No. EL/3.2.3

**SPECIAL MAINTENANCE INSTRUCTION No**  
**RDSO/2006/EL/SMI/0240(REV. '1')**

Measures to improve the quality of smoothing reactors (SL-42/30) during manufacturing /maintenance.

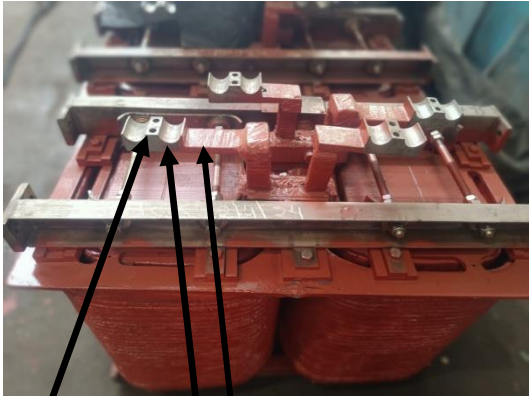
<p>connection bar with external coil end. Coil-1 Coil-2</p>  <p><b>Braze fixed cleat      Connection bar</b> <b>Braze joint</b></p> <p>Picture showing fixed terminal cleat brazed on connection bar (161X50X10 mm thick) and connection bar with external coil end.</p>	<p>connection bar (161X50X10 mm thick) and connection bar with external coil end shall be made at ambient temperature through V/I method by injecting the rated direct current (1350 Amp for SL-30) through the coil.</p> <p>The measured resistance shall be corrected to reference temperature 115°C as per following formula:</p> $R_{115} = \frac{R_a \times 349.9}{234.5 + t_a}$ <p>Where, R<sub>115</sub> is corrected resistance at 115°C. R<sub>a</sub> is the resistance at ambient temperature and t<sub>a</sub> is ambient temperature. R<sub>115</sub> shall be 3.645 ± 0.056 milli-ohm</p> <p><b>The milli-volt drop corrected at 115°C = 4.92 ± 0.076 Volt.</b></p>
